KEYSTONE XL PIPELINE PROJECT

0383-SD-P4-524.1-524.4-1

Proposed Route Variation 0383-01

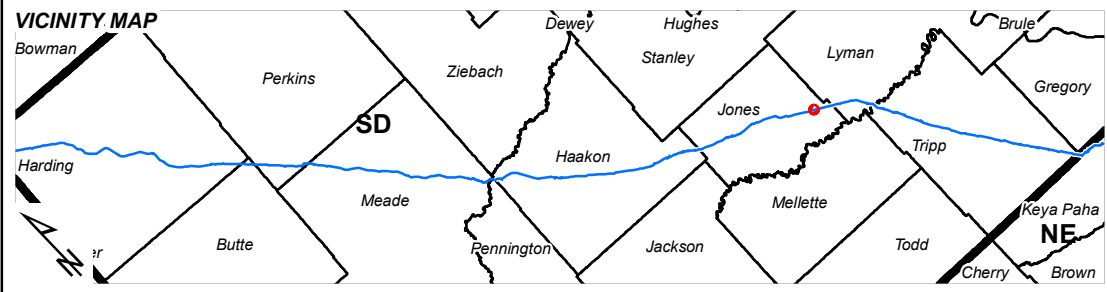
3	REASON FOR ROUTE VARIATION (Please include reason for route variation):		
	<p>The primary reason for this route variation is to improve the crossing of the West River Lyman Jones Waterline (WAT-8034, 2.5 diameter) near MP 524.55. The crossing angle of the pipeline at the waterline is improved from 10° to 50°.</p> <p>This proposed reroute is requested by Engineering and is proposed based on the recommendations from the CPMS 60% Design Review. The proposed reroute was drawn based on a combination of aerial imagery, Pictometry, and LIDAR data.</p>		
	DETAIL ROUTE VARIATION (Please describe route variation in detail):		
	<p>The proposed route variation starts near MP 524.2 and deviates ~1.5° southeast of the current centerline. It extends in this direction for ~669.5 ft. prior to turning northeast towards the current CL. This turn, allows for a 50° crossing of the WRLJ waterline. The proposed reroute continues in this direction for ~119 ft. Then the reroute turns southeast and continues for ~576 ft to rejoin the current CL near MP 524.4.</p>

ADDITIONAL IMPACTS (Please include any additional impacts which may affect cost; crossings, induction bends, etc.):		
	<p>1 Tract is impacted by this centerline reroute: ML-SD-JO-10880.000 (Ted L. Nies & Beverly J. Nies, Douglas P. Nies)</p> <p>The proposed route variation falls within the current environmental surveyed corridor, so no additional costs associated with environmental surveys will be incurred. Additionally, the bore length is reduced from 30 ft. to 10 ft. crossing.</p>		
	Is there an increase/decrease in the number of crossings?	Yes <input type="text"/>	No <input checked="" type="checkbox"/> X
	If yes, please list: <input type="text"/>		
	COST ANALYSIS (costs incurred or saved from the route variation)		
	Additional length of route realignment:	<input type="text" value="20"/> ft.	\$ <input type="text" value="7,140.75"/> \$ 360/ft
	Additional length of side-hill construction:	<input type="text" value="0"/> ft.	\$ <input type="text" value="-"/> \$ 19/ft
